SUBJECT: ISSUANCE OF AMENDMENT NO. 82 TO FACILITY OPERATING
LICENSE NO. NPF-6 - ARKANSAS NUCLEAR ONE, UNIT NO. 2
(TAC NOS. 66521 AND 66556)

AMENDMENT TO FACILITY OPERATING LICENSE

Amendment No. 82
License No. NPF-6

SAFETY EVALUATION BY THE OFFICE OF NUCLEAR REACTOR REGULATION

FIGURE 3.1-1

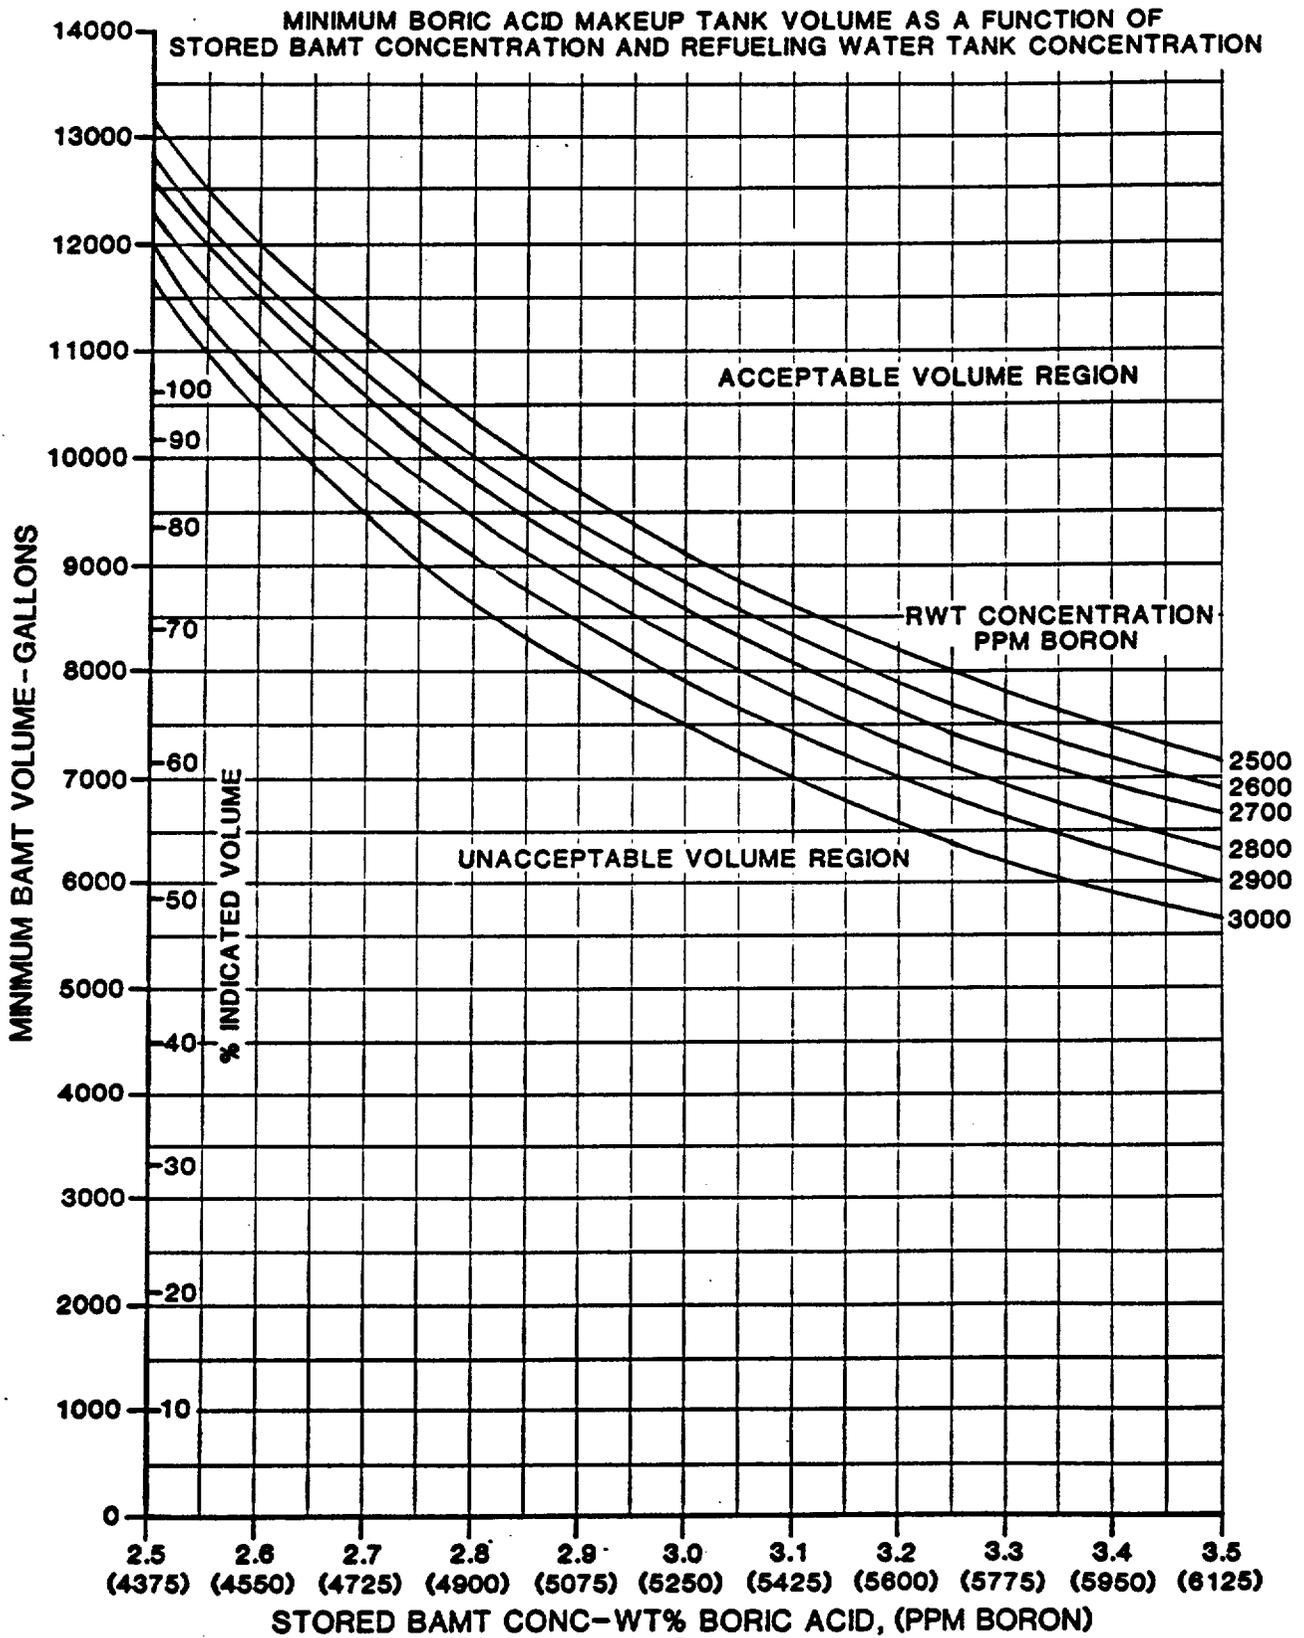
- 3.1.2.2 The following boron injection flow paths shall be OPERABLE, depending on the volume available in the boric acid makeup tanks.
- a. If the contents of ONE boric acid makeup tank meet the volume requirements of Figure 3.1-1, two of the following three flow paths to the Reactor Coolant System shall be OPERABLE:

3. One flow path from the refueling water tank via a charging pump.
- OR
- b. If the contents of BOTH boric acid makeup tanks are needed to meet the volume requirements of Figure 3.1-1, four of the following five flow paths to the Reactor Coolant System shall be OPERABLE:

- a. At least one of the following sources with a minimum solution temperature of 55°F:
 1. One boric acid makeup tank, with the tank contents in accordance with Figure 3.1-1, or
 2. Two boric makeup tanks, with the combined contents of the tanks in accordance with Figure 3.1-1, and
- b. The refueling water tank with:
 1. A contained borated water volume of between 464,900 and 500,500 gallons (equivalent to an indicated tank level of between 91.7% and 100%, respectively),
 2. Between 2500 and 3000 ppm of boron,
 3. A minimum solution temperature of 40°F, and
 4. A maximum solution temperature of 110°F.

Since the proposed revision would allow the boron concentration in the BMTs to be as low as 2.5 weight percent, the minimum BMT volume of approximately 13,150 gallons required by TS Figure 3.1-1 as a function of BMT and RWT concentration would not be met with only one BMT. Therefore, the proposed revision would provide an option for combining the contents of both BMTs at low concentrations. When both BMTs are required, two independent flow
